DEPARTMENT OF TRANSPORTATION**DIVISION OF ENGINEERING SERVICES**

Contract #: 04-0120F4Cty: SF/ALA Rte: 80 PM: 13.2/13.9File #: 69.28**WELDING INSPECTION REPORT****Resident Engineer:**Pursell, Gary**Address:** 333 Burma Road**City:** Oakland, CA 94607**Report No:** WIR-007481**Date Inspected:** 08-Jun-2009**Project Name:** SAS Superstructure**OSM Arrival Time:** 645**Prime Contractor:** American Bridge/Fluor Enterprises, a JV**OSM Departure Time:** 1845**Contractor:** Zhenhua Port Machinery Company, Ltd (ZPMC), Changxing Island **Location:** Shanghai ,China**CWI Name:** Li Yan Hua**CWI Present:** Yes No**Inspected CWI report:** Yes No N/A**Rod Oven in Use:** Yes No N/A**Electrode to specification:** Yes No N/A**Weld Procedures Followed:** Yes No N/A**Qualified Welders:** Yes No N/A**Verified Joint Fit-up:** Yes No N/A**Approved Drawings:** Yes No N/A**Approved WPS:** Yes No N/A**Delayed / Cancelled:** Yes No N/A**Bridge No:** 34-0006**Component:** OBG Assembly**Summary of Items Observed:**

Segment 5CW

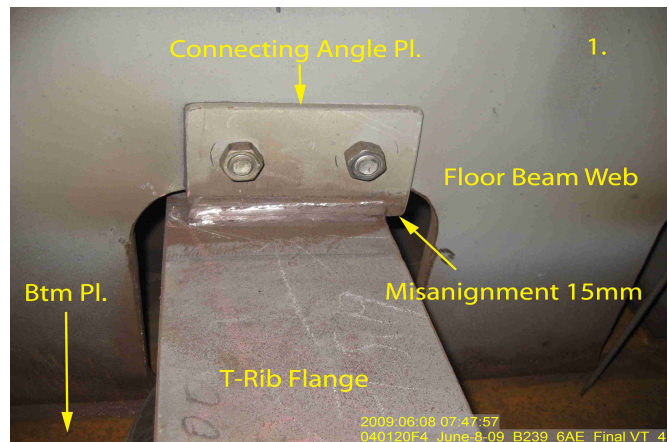
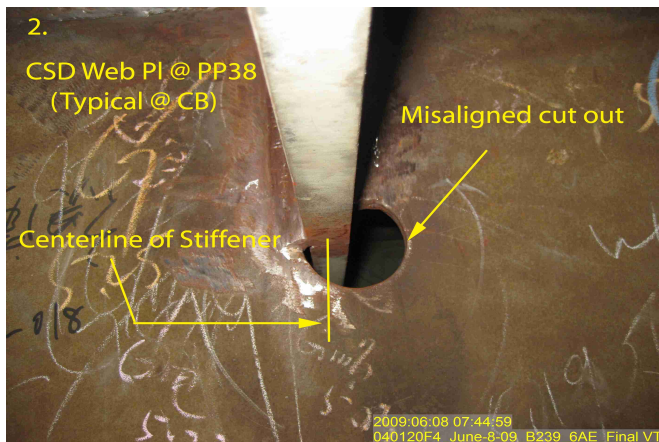
This QA Inspector performed a preliminary random visual inspection of the Upper Internal structure of this segment after the grit blast. Areas that were marked to be ground were repaired and areas that were marked to be welded were taped and noted to be repaired at the trial assembly yard. The ZPMC (QA) representatives were not present at the time of inspection.
